Re: Public Consultation on New Evidence Base Documents – Tunbridge Wells Borough Council Local Plan

PS 095 Policy STR/SS1 – the Strategy for Paddock Wood including Land at East Capel

Policy STR/SS 1

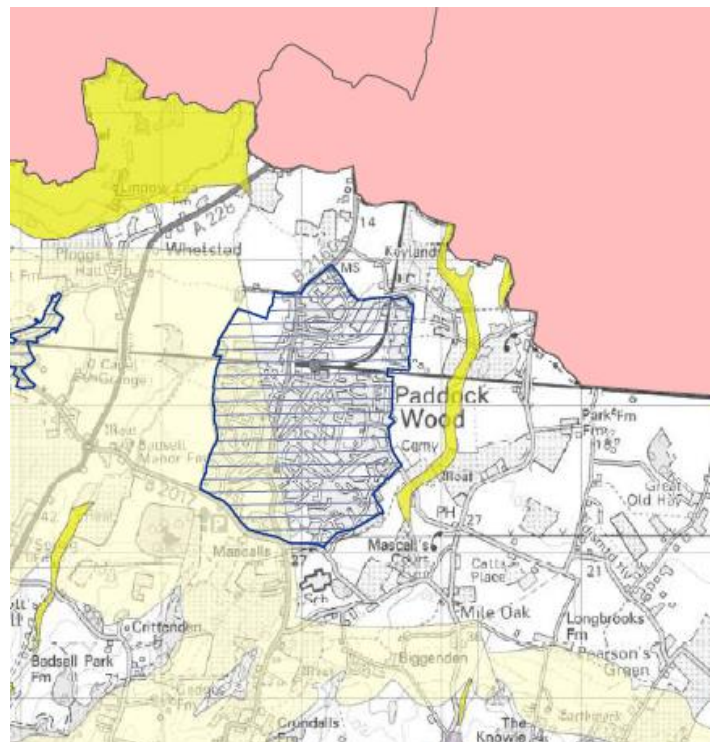
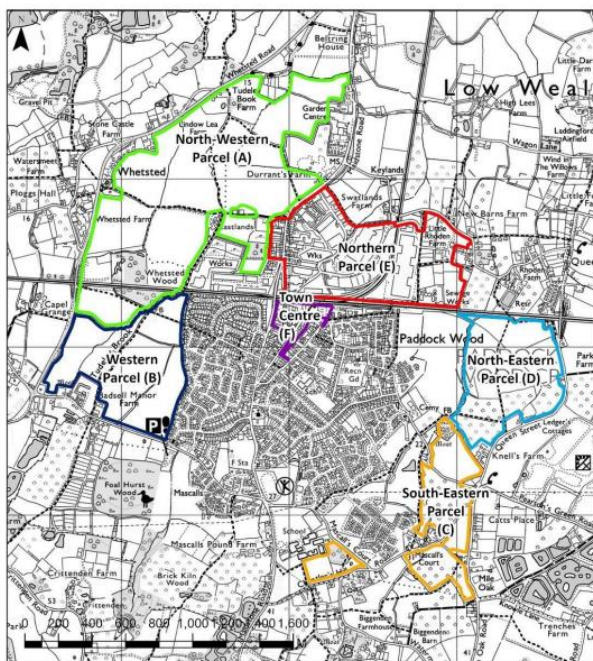
The County Council, as Minerals and Waste Planning Authority, notes previous commentary raised in respect of safeguarded land won mineral issues in Capel and Paddock Wood. It is assumed that the land parcels A, D and C of Policy STR/SS 1 constitute areas for development allocation (that are coincident with the two safeguarded land won minerals, see extracts below) are a reduction in overall size since the submission of the Local Plan.

The County Council, as Mineral Planning Authority, has previously commented on the mineral safeguarding matters that affect the safeguarded mineral interests in the Paddock Wood and Capel area and draws attention to the previous comments. In particular, Policy

SRT/SS 1 affects safeguarded minerals. The TWBC Local Plan should therefore refer to these safeguarded minerals and ensure that it references how an exemption from the presumption to safeguard these deposits in accordance with Policy DM 7 of the Kent Minerals and Waste Local Plan 2013-30 (Early Partial Review 2020) is justified. From the information currently available, the County Council considers that a viable case for the prior extraction of the minerals is likely to be low.
